Reference: Hanford Waste Vitrification Plant
DOE Contract DE-AC06-86RL10838
Fluor Contract 8457

DESIGN CHANGE NOTICE

DCN -0100 | REV 0 | PAGE 1 OF 18

DCN TITLE: THIS DCN-0100 SUPERSEDES "DCN-0096" & "DCN-0096 REV 1"

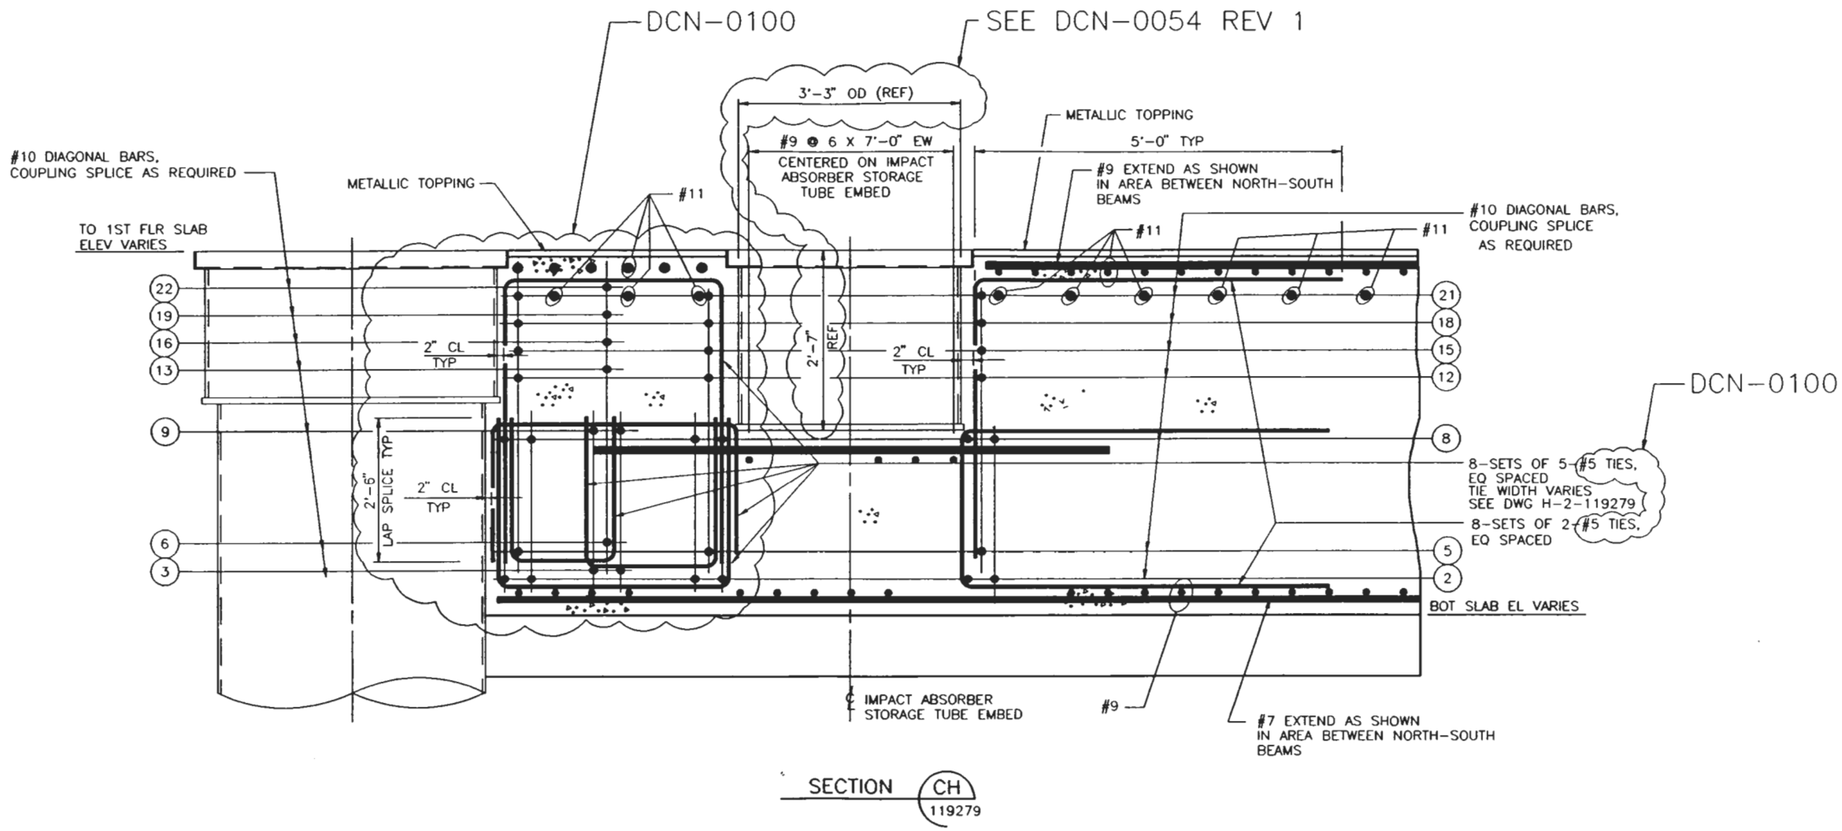
NUMBER	REV	DATE	TITLE
DCN NUMBER - 0100	0	08/30/93	DCN TITLE - THIS DCN -0100 SUPERSEDES "DCN-0096 & 0096R1 "APPROVED FOR CONSTRUCTION" THE ADDITIONAL REINFORCING TIE CHANGES WERE MADE ON THIS DCN-0100: SEE TIES ON SECTION F & 7, SECTION G & DET 27 PAGE 8, SECTION Y & Z PAGE 9, SECRION CA PAGE 10 AND SECTION CH PAGE 11

FLUOR DANIEL	U.S. DEPARTMENT OF ENERGY HANFORD WASTE VITRIFICATION PLANT	DESIGN CHANGE NOTICE
DESCRIPTION OF CHANGE: REMOVE HOLD HWVP-FD-372. REVISE REINFORCING TIES. REVISE IMPACT ABSORBER STORAGE TUBE EMBED DIMENSIONS.		BASE DOC. NO. H-2-119280 SHT/PG. 3 REV. 1 CR NO. CR-HWVP-1025 DISCIPLINE: STRUCTURAL/DCN0096R
PREPARED BY: Armando Villegas	DATE: 8/30/93	DCN - 0100 REV. 0 PAGE 11
DISCIPLINE ENGINEER: Rale J. Amber	DATE: 8-30-93

DETAIL 98 / 119276

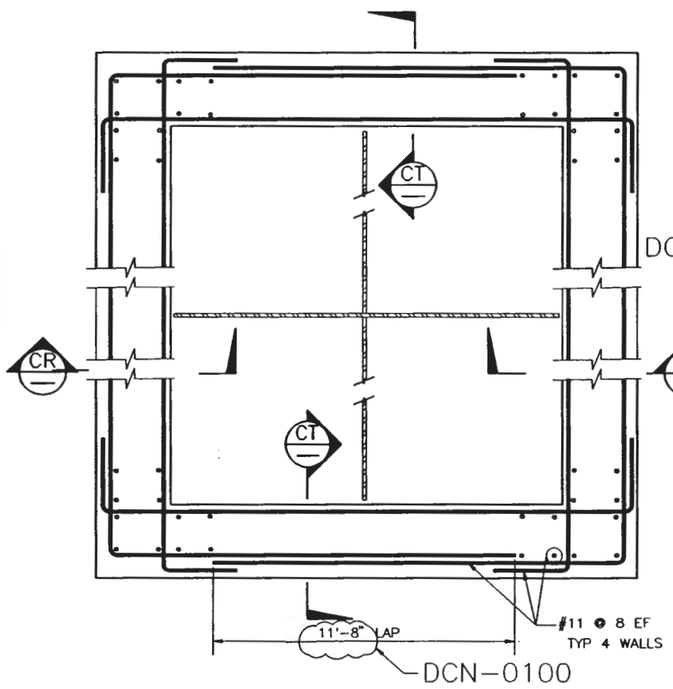
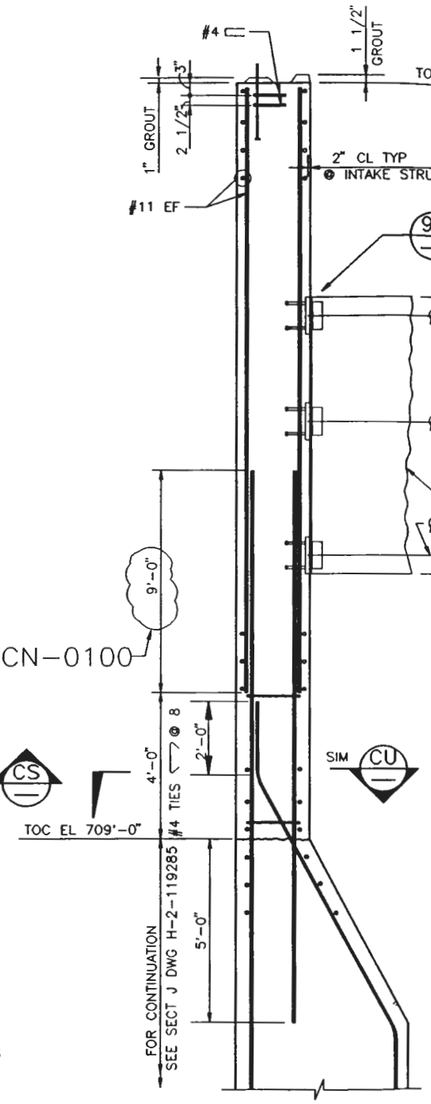
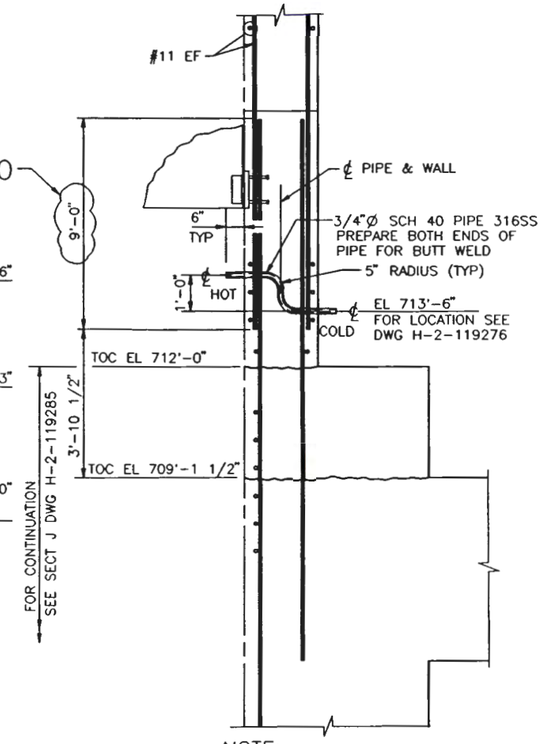
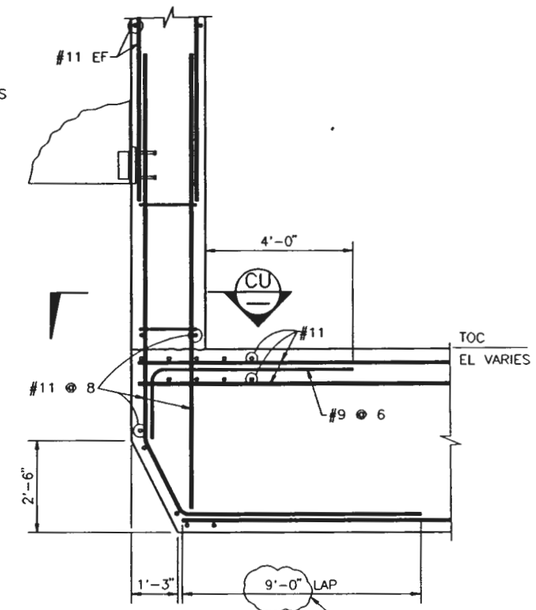
FLUOR DANIEL — U.S. DEPARTMENT OF ENERGY, HANFORD WASTE VITRIFICATION PLANT		DESIGN CHANGE NOTICE
DESCRIPTION OF CHANGE: REMOVE HOLD HWVP-FD-372. REVISE REINFORCING LAPS.		BASE DOC. NO. H-2-119280; SHT/PG. 3; REV. 1; CR NO. CR-HWVP-1025; DISCIPLINE: STRUCTURAL/DCN0096S
PREPARED BY: Armando Villegas	DATE: 8/30/93	DCN - 0100 · REV. 0 · PAGE 12
DISCIPLINE ENGINEER: Robert J. Imber	DATE: 8-30-93

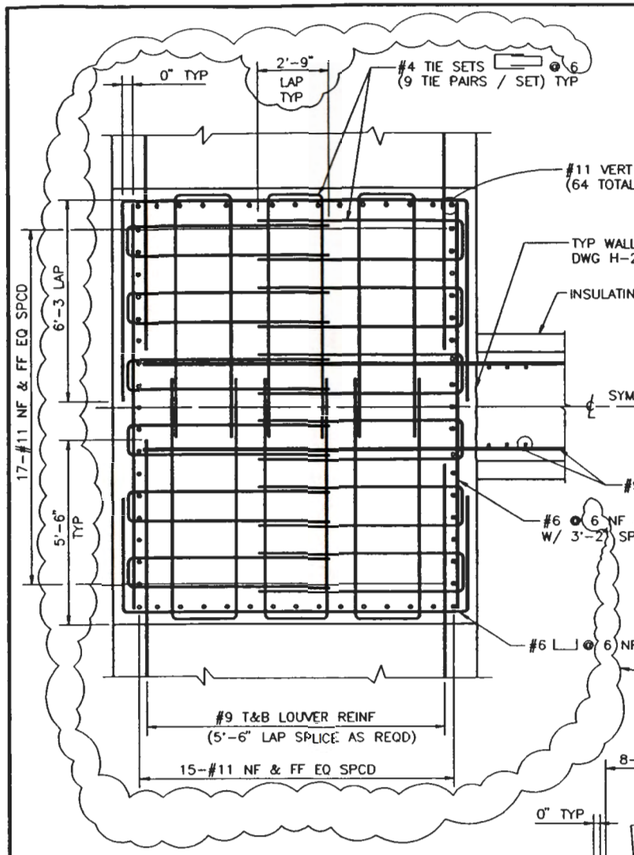
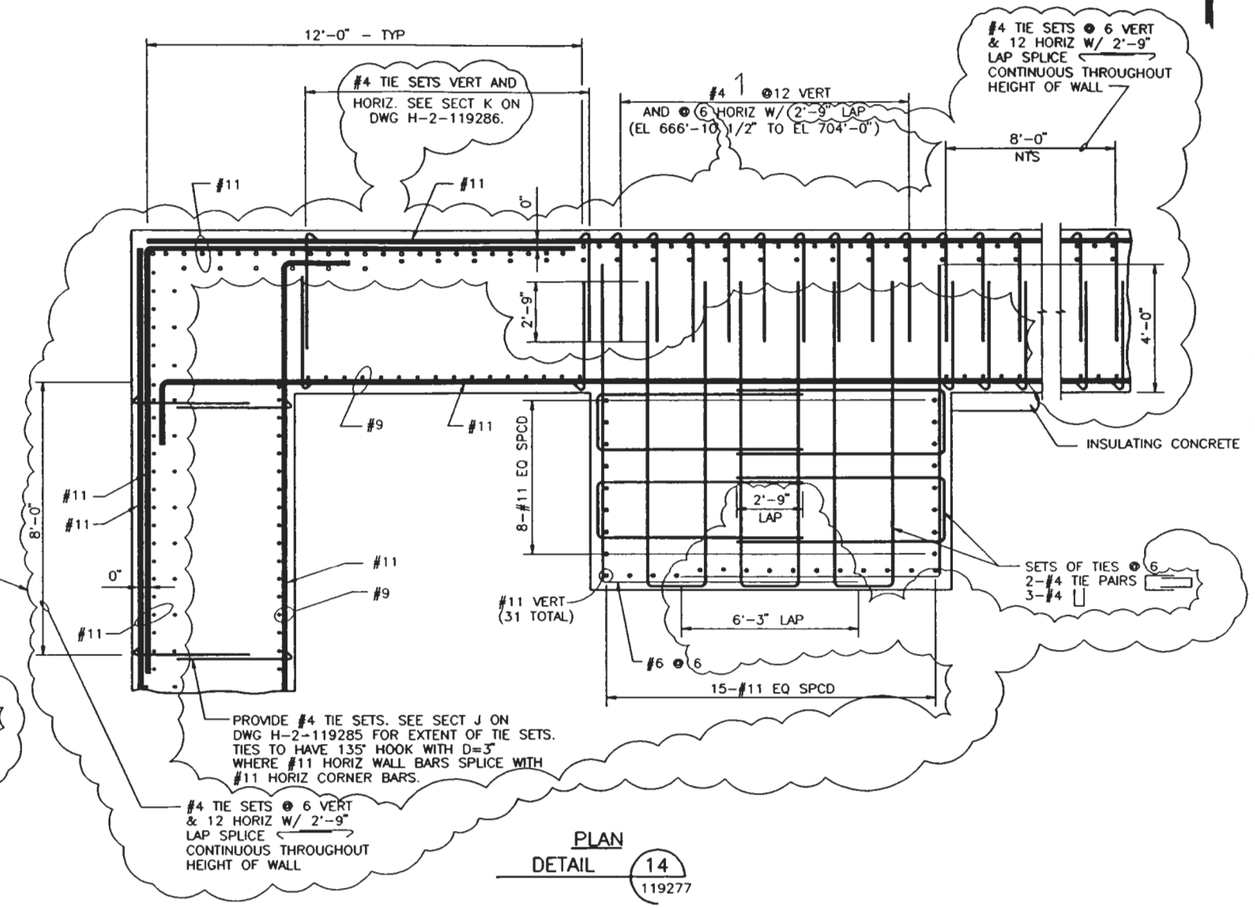
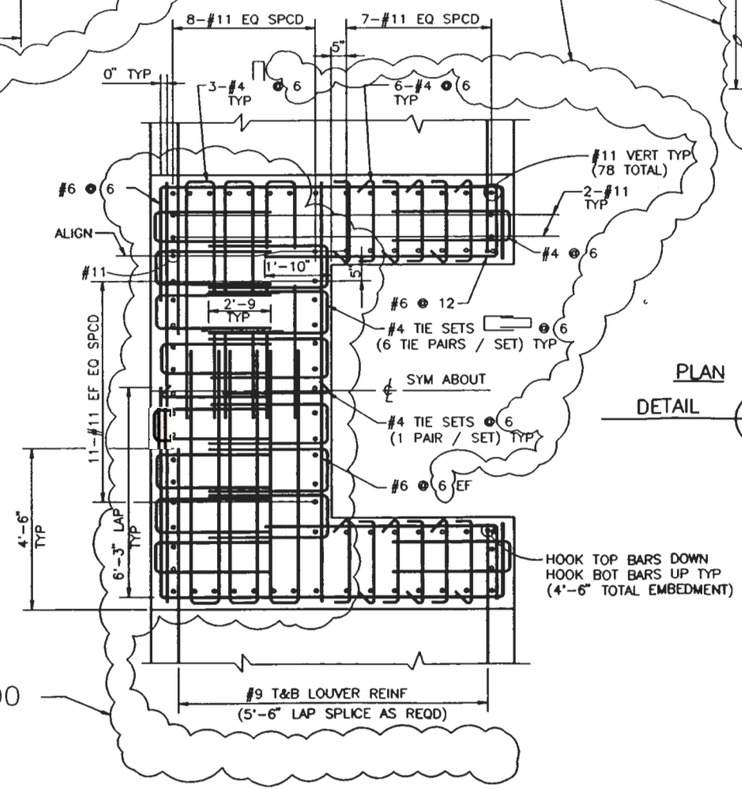
FLUOR DANIEL	U.S. DEPARTMENT OF ENERGY HANFORD WASTE VITRIFICATION PLANT	DESIGN CHANGE NOTICE		
DESCRIPTION OF CHANGE REMOVE HOLD HWVP-FD-364. REVISE REINFORCING AS NOTED AND REMOVE LENTON COUPLER NOTES.		BASE DOC. NO. H-2-119281 SHT/PG. 1 REV. 2 CR NO. CR-HWVP-1025 DISCIPLINE: STRUCTURAL/DCN0096J		
PREPARED BY: Armando Villegas	DATE: 8/30/93	DCN - 0100	REV. 0	PAGE 13
DISCIPLINE ENGINEER: Robert J. Gruber	DATE: 8-30-93

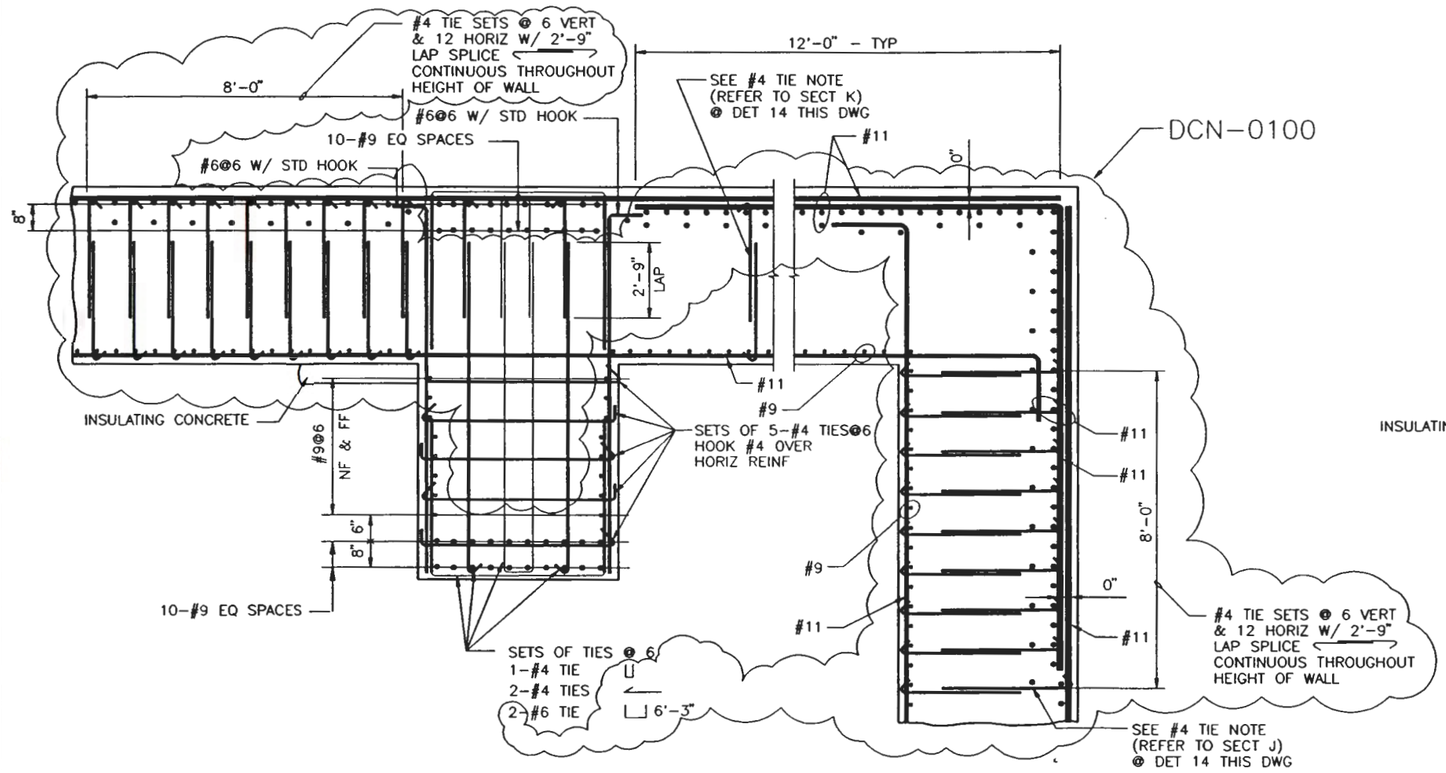
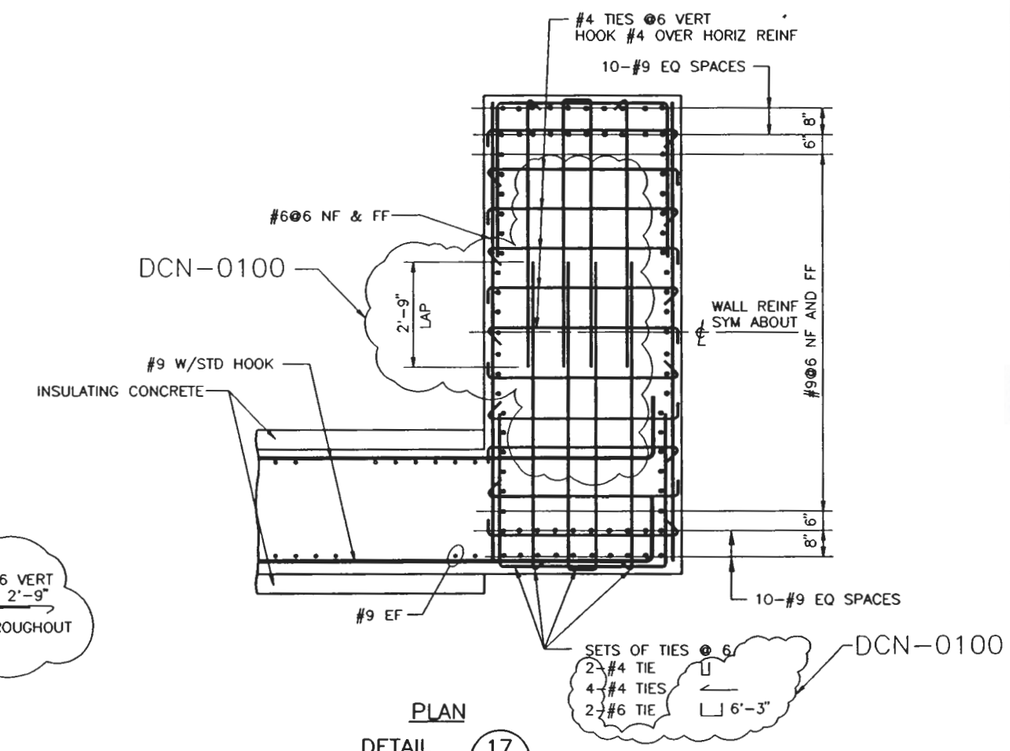
FLUOR DANIEL	U.S. DEPARTMENT OF ENERGY HANFORD WASTE VITRIFICATION PLANT	DESIGN CHANGE NOTICE	
DESCRIPTION OF CHANGE: REMOVE HOLD HWVP-FD-364. REVISE REINFORCING AS NOTED.		BASE DOC. NO. H-2-119281	
		SHT/PG. 1	REV. 2
		CR NO. CR-HWVP-1025	
		DISCIPLINE: STRUCTURAL/DCN0096K	
PREPARED BY: Armando Villega	DATE: 8/30/93	DCN - 0100	REV. 0 / PAGE 14
DISCIPLINE ENGINEER: Rob Drueber	DATE: 8-30-93

SECTION CP 119279

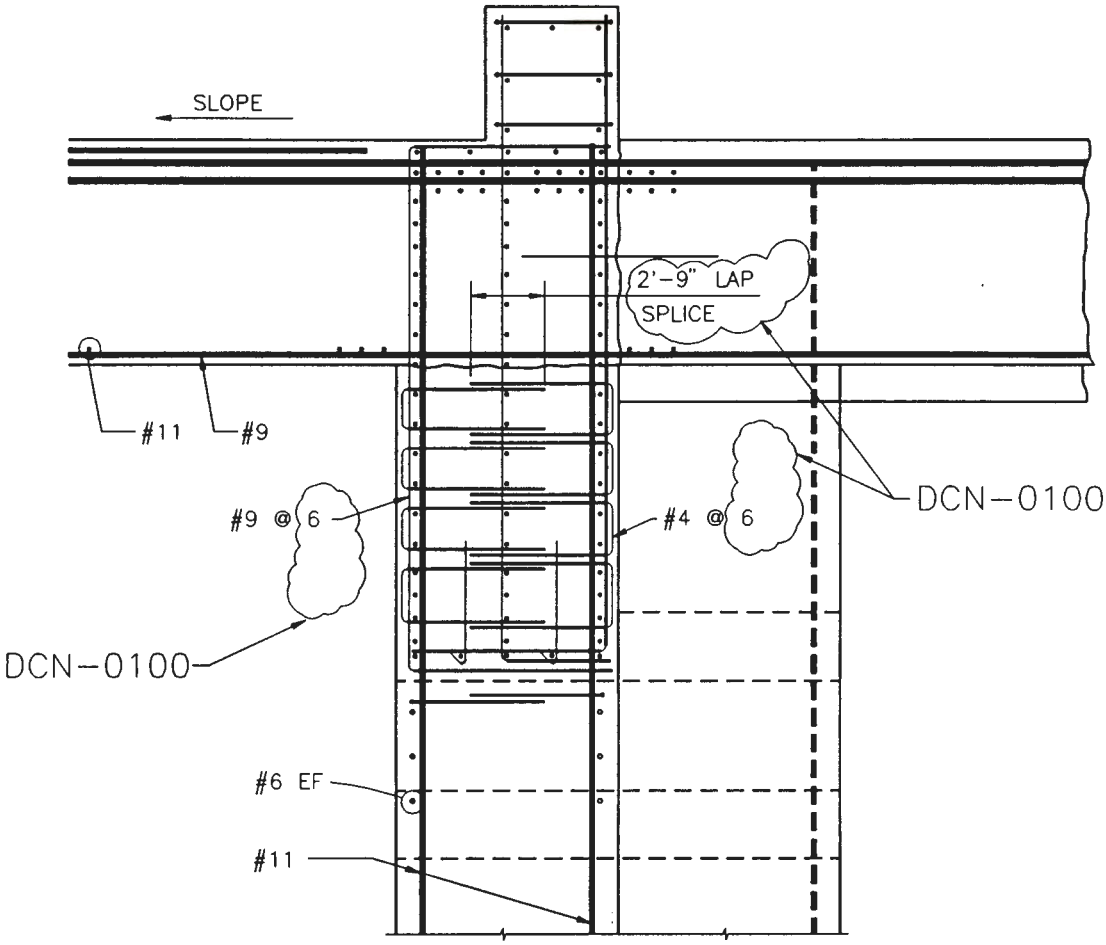
FLUOR DANIEL	U.S. DEPARTMENT OF ENERGY HANFORD WASTE VITRIFICATION PLANT	DESIGN CHANGE NOTICE
DESCRIPTION OF CHANGE: REMOVE HOLD HWVP-FD-364. REVISE REINFORCING SPACING AND TIE LAP AS NOTED.		BASE DOC. NO. H-2-119281 SHT/PG. 2 REV. 0 CR NO. CR-HWVP-1025 DISCIPLINE: STRUCTURAL/DCN0096H
PREPARED BY: Armando Villega	DATE: 8/30/93	DCN - 0100 REV. 0 PAGE 15
DISCIPLINE ENGINEER: Robert Fowler	DATE: 8-30-93

DETAIL J 119279

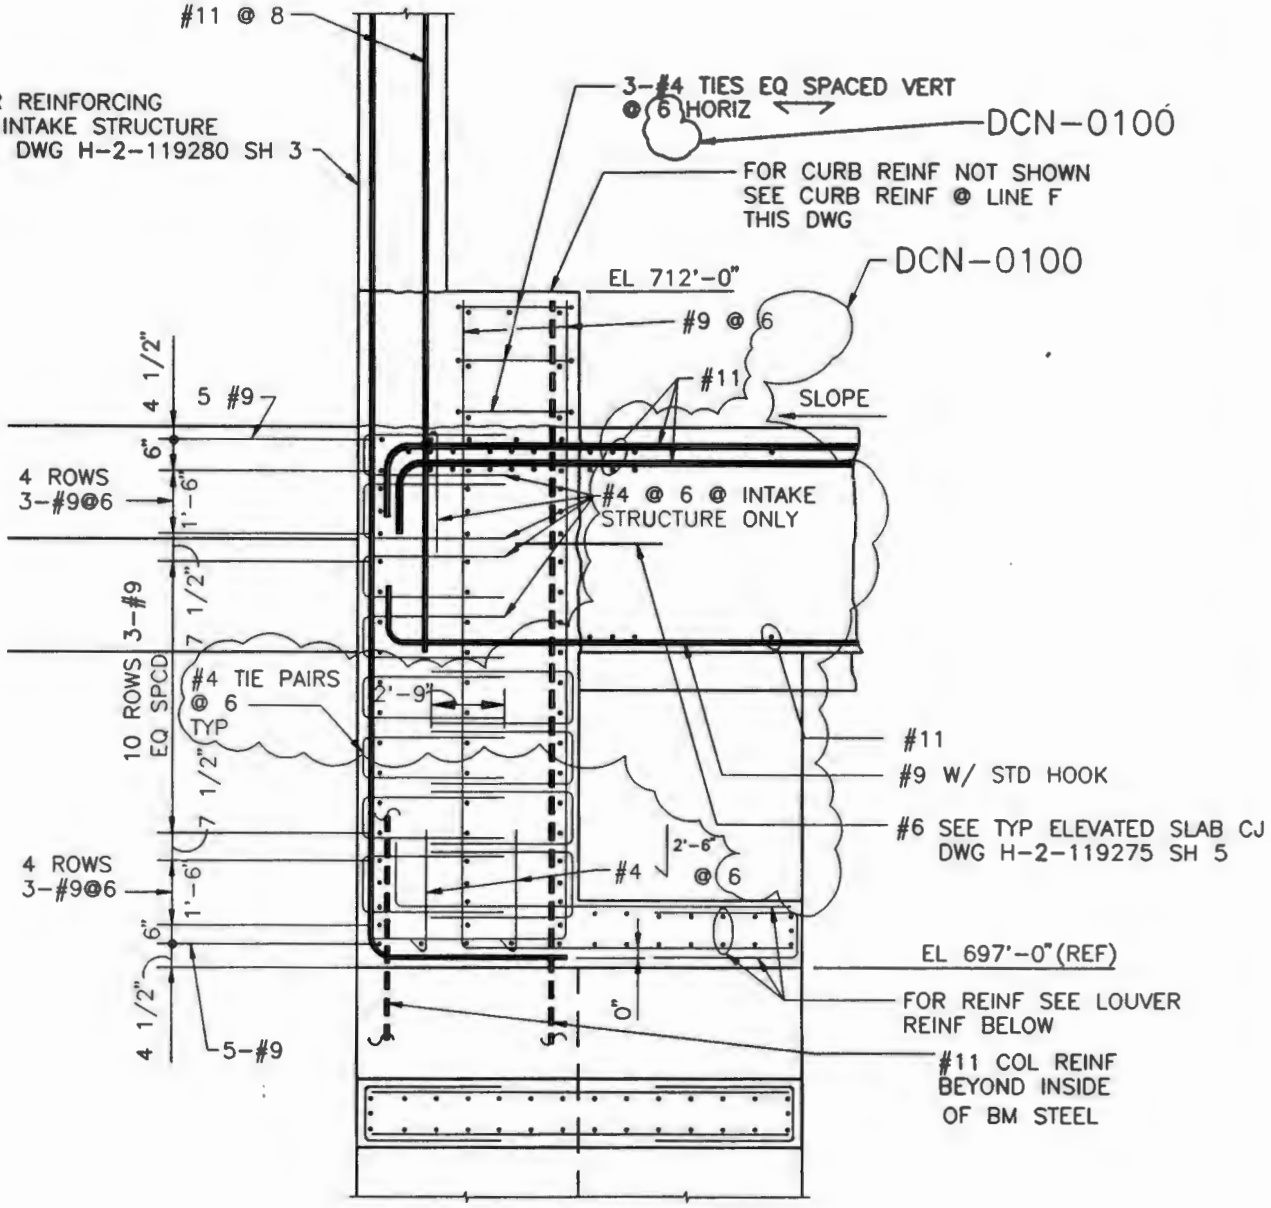
FLUOR DANIEL	U.S. DEPARTMENT OF ENERGY HANFORD WASTE VITRIFICATION PLANT	DESIGN CHANGE NOTICE
DESCRIPTION OF CHANGE: REMOVE HOLD HWVP-FD-364. REVISE REINFORCING SPACING AND TIE LAP DIMENSION		BASE DOC. NO. H-2-119285 SHT/PG. 1 REV. 2 CR NO. CR-HWVP-1025 DISCIPLINE: STRUCTURAL/DCN0096E
PREPARED BY: Armando Villegas	DATE: 8/30/93	DCN - 0100 REV. 0 PAGE 16
DISCIPLINE ENGINEER: Robert A. Dunbar	DATE: 8-30-93
